Our Ref: 20168 LPA3 GC

**PP/23/00968 Demolition of existing building and redevelopment for new building up to four storeys and basement (Use Class E - commercial, business and service); roof terraces, landscaping works; installation of plant; and associated works. (MAJOR APPLICATION) at 81-103 (odd) King's Road, LONDON, SW3 4NX**

I write to **OBJECT** to the above planning application, on behalf of the Directors of the Board of Charles II Place Management (1991) Limited ('the Board of CIIP'), in relation to this neighbouring redevelopment. The Board of CIIP also own no. 51 Charles II Place. It is requested that the strong objections raised with regard to the impact of the proposal on the residents of Charles II Place (CIIP) are taken fully into consideration prior to determination of the application.

*Photograph taken from ground level in front of the houses at 1-3 CIIP, showing the current outlook. Note the facing windows of 51 CIIP close to the boundary with the development site*

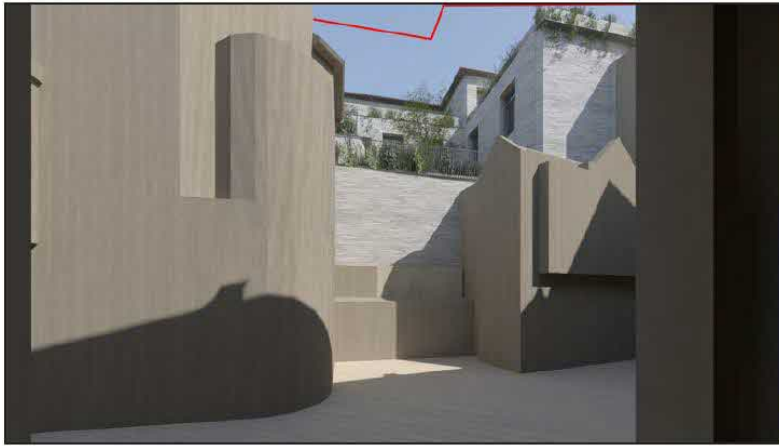
2.25 The built development to the front of the houses at 1-3 CIIP proposes a change from the existing maximum 2-storey development - where the existing ground floor of the M&S is set away from the houses and the existing first floor set a further 5m back (as shown in the above photograph) – to a 4 storey development built on that eastern boundary, set back at first floor level by only approx. 3.5m, with upper floors rising up to a 4 storeys plus roof with a staggered building line, including external terraces. The scale and proximity of the proposal is shown in the visual overleaf (the red line representing the refused Benoy scheme).

View from 3 Charles II Place- ground floor window- PLANNING PROPOSAL (previous rejected scheme shown in outline).

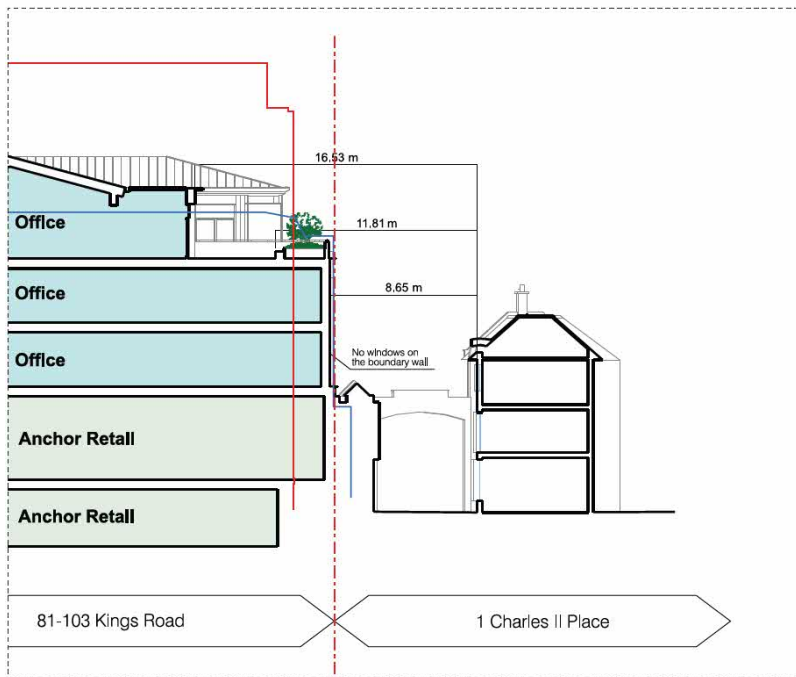
*Extract from the Design and Access Statement showing the new building from 3 CIIP. The facing wall shows the proposed edge of an external terrace. No. 51 CIIP is the two-storey building on the right-hand side of the visual.*

2.26 There will be a fundamental change to the outlook and sense of enclosure to these houses. The proposal will materially and significantly worsen the residential amenity of the occupiers of these properties, in terms of creating an increased sense of enclosure and significant loss of outlook, which will be all the more marked due to the essentially single aspect nature of these dwellings, meaning the outlook from their west facing windows is all the more important to their occupiers.

Left: Section illustrating the interface of 1 Charles II Place with the Proposed Scheme

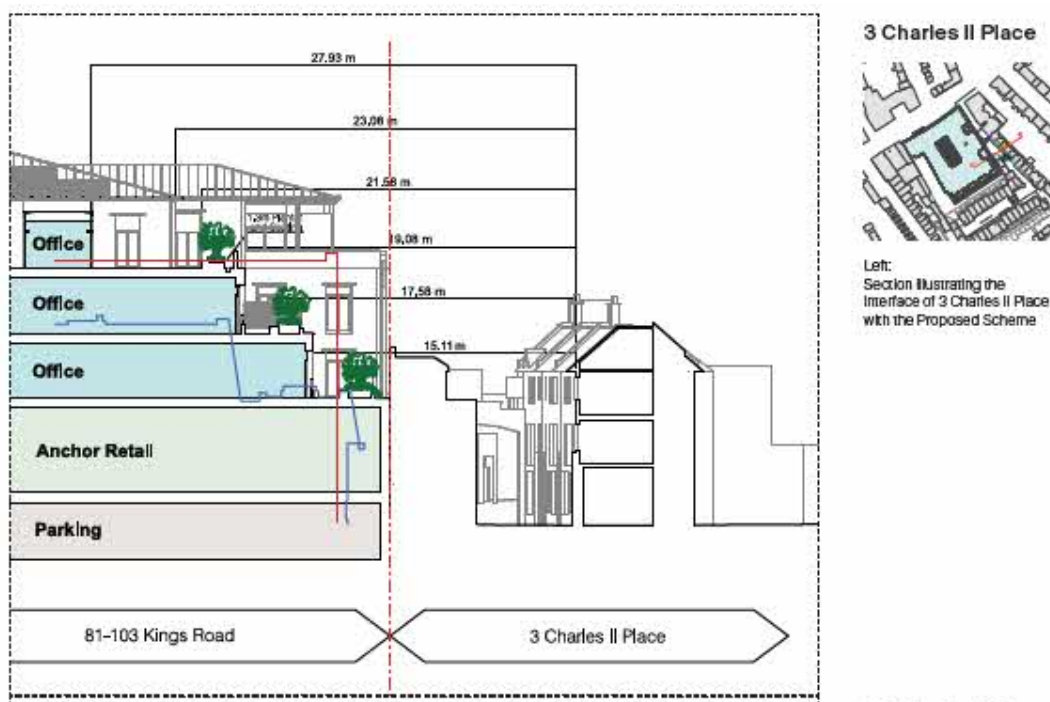
*Extract from Design and Access Statement showing an 8.65m distance between the front of the house at no. 1 CIIP to the proposed 3 storey flank wall which will face onto it.*

*Outlook from ground floor kitchen window of the house at no. 38 CIIP.*

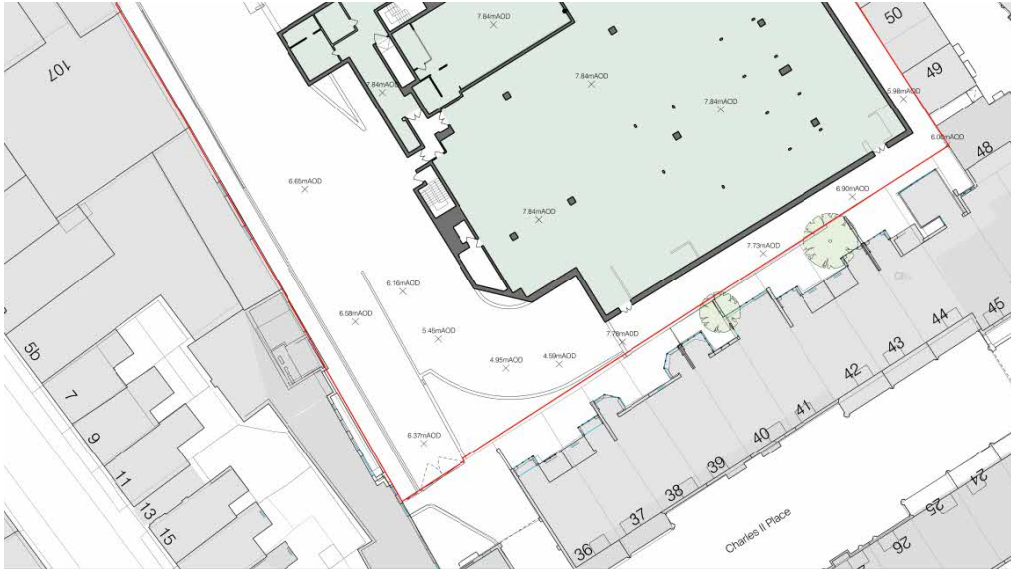
2.29 The set back will be replaced by a bank of 4 storey high terraces. The submitted visuals in the Design and Access Statement are somewhat misleading as a 2D representation does not provide a true reflection of distance, so the existing M&S building appears to be as close as the new building, which is not the case. The occupiers of these flanking houses will experience a material change to their outlook and a significant increase in enclosure to the rear of their properties and gardens.

*Extract from Proposed Ground Floor Plan, showing the new building only some 3 to 4 metres to the rear boundary with houses nos. 36-40 CIIP. This plan also shows the proximity of plant, generators and servicing to the CIIP houses.*

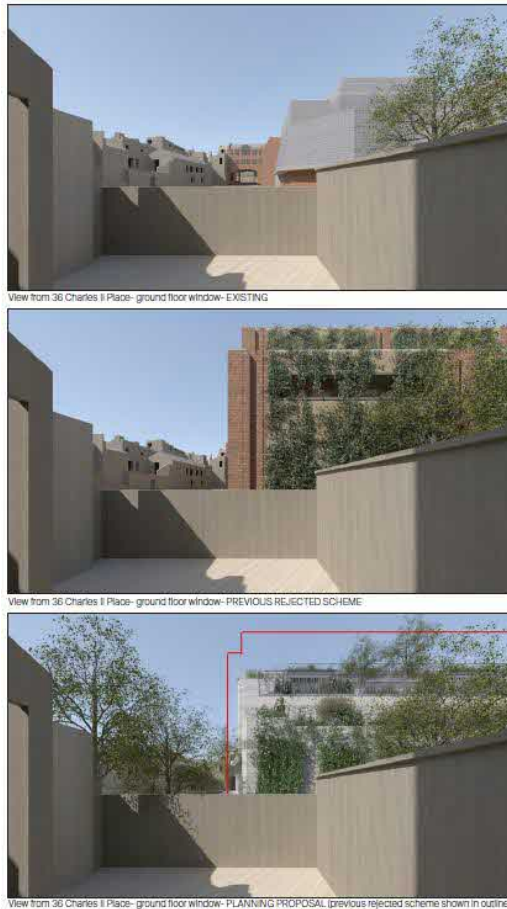
2.30 In practice, on both the southern and eastern elevations of the development the proposed new building will introduce a taller and bulkier built form than currently exists, and the bulk of the new building will be significantly closer to the site boundaries, creating a harmful increase in the sense of enclosure and an overbearing and over-dominant impact to these houses and their gardens. The proposal is clearly contrary to Policy CL5 of the Local Plan and Policy D3 of the London Plan.

*Photograph showing existing separation between the eastern elevation of the M&S building and the houses at nos. 49-51 CIIP. This will be 'filled in' by the new proposal. The header of one of the first-floor windows in no. 51 CIIP is visible in the photograph.*

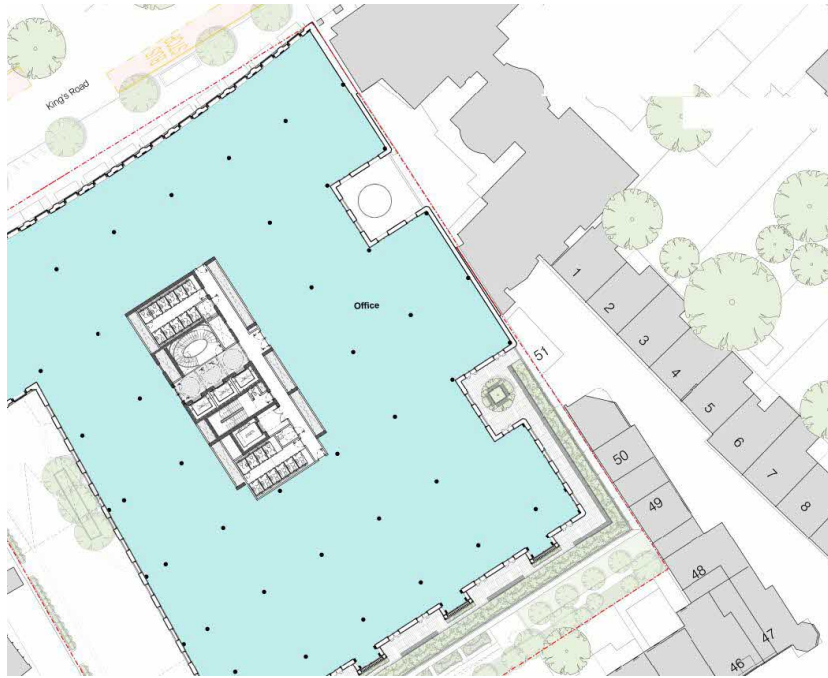
2.32 The new scheme includes a number of external terraces to the east and south elevation of the new building; they are an integral and significant part of the proposal. An external terrace is proposed to the 'gap' between 50 and 51 CIIP and will not only be immediately next to the side walls of houses at 49, 50 and 51, permitting views into the first floor windows of houses nos. 50 and 51, which are set at 90 degrees to the balcony, but it will also facilitate clear views into the houses opposite (1 – 4 CIIP) which lie only between 8.6m - 11 m from this terrace. This creates the potential for direct overlooking from this terrace into the windows of these houses.

2.33 It is noted at the pre-application stage that the proximity and comparable height of the terraces to the windows on Charles II Place properties was raised as a concern (Pre-App 1) with officers commenting that 'Even with the section drawings provided and the planting buffer it would appear direct and close (e.g. around 11.5m to 12m) views would be possible. In their response to the pre-app in December 2022, officers stated 'I remain unconvinced that the planters and controls on hours of access would be sufficient to overcome this issue. You should further explore options here however, I remain of the opinion that this level of terrace [first floor] should be removed from the proposals.' Furthermore, the officer states 'You do not appear to have addressed my concerns about the terraces and windows to the east and the relationship with 1 to 3 Charles II Place. The distance is greater than the southern relationship however, my concerns set out previously remain and should be addressed in the submission through appropriate changes and/or mitigation.'

*Extract from Proposed First Floor Plan showing the opportunity for direct overlooking of the windows of a number of the houses at CIIP to the east and south, as well as demonstrating the proximity of the new building to the rear walls of 48-51 CIIP.*

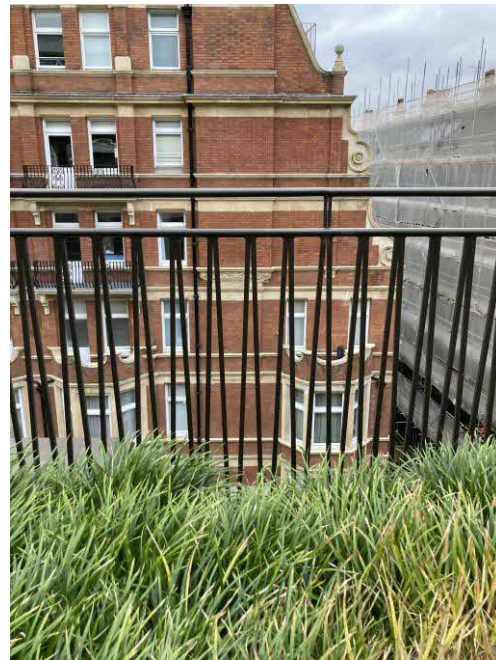
- 2.34 The presence of the terraces and the efficacy of the planters to prevent overlooking was clearly an issue for the Council at the pre-application stage and the submitted proposal does not address this issue. The ‘generously planted planters’ will not offer proposed screening of the terraces from the neighbours’ planters or the neighbours’ houses from the terrace – in addition, there is an area adjacent to the back wall of the house at no. 51 CIIP where no landscaping is present.

*Photographs showing the planters at 127 Kensington which face onto Kensington High Street and Wrights Lane at a busy commercial intersection. The windows to the flats opposite are visible despite the presence of planters.*

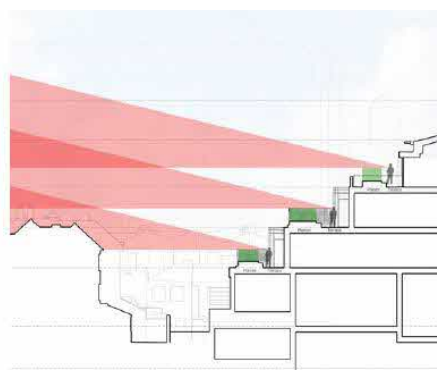
- 2.35 At the architect’s request, I visited 127 Kensington High Street and saw planters in situ on that building. The visit confirmed by concerns that the planters certainly do not prevent overlooking – see the photos overleaf. Even were these planters densely planted with a more robust, taller and denser screen, relying on plants to prevent overlooking is problematic given that living things take time to grow and establish, will die, and do not always grow in the manner desired. They offer no protection against the passage of noise or light. In addition, they do not reduce the ‘feeling’ of being overlooked.

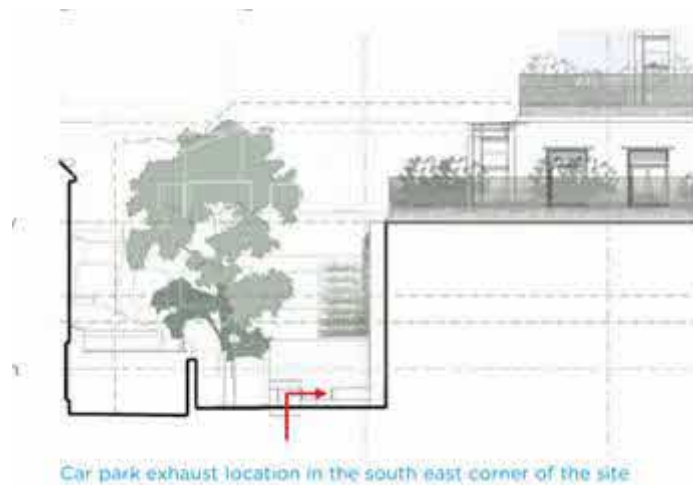
2.43.3 The applicant's survey location was towards the King's Road, on the roof of the M&S with a line of sight to King's Road and located near to existing plant; this does not adequately represent the noise climate in the rear gardens and houses of CIIP. Sharps Redmore confirm that there is an arched access to CIIP off Kings Road and the survey location undertaken by the applicants would have been influenced by road traffic noise along Kings Road, providing higher ambient and background noise levels. The rear gardens of the properties on CIIP do not have line of sight to the King's Road and are reflective of the quietness and tranquillity of the estate. The survey undertaken by Sharps Redmore within the rear gardens of numbers 39 and 43 over a 72-hour period shows background levels significantly lower than those measured and used in the supporting noise document produced by the applicants. Subjectively, CIIP is surprisingly quiet for this part of London. CIIP is effectively screened on all sides from road traffic noise, and it is aircraft that is the most noticeable noise source.
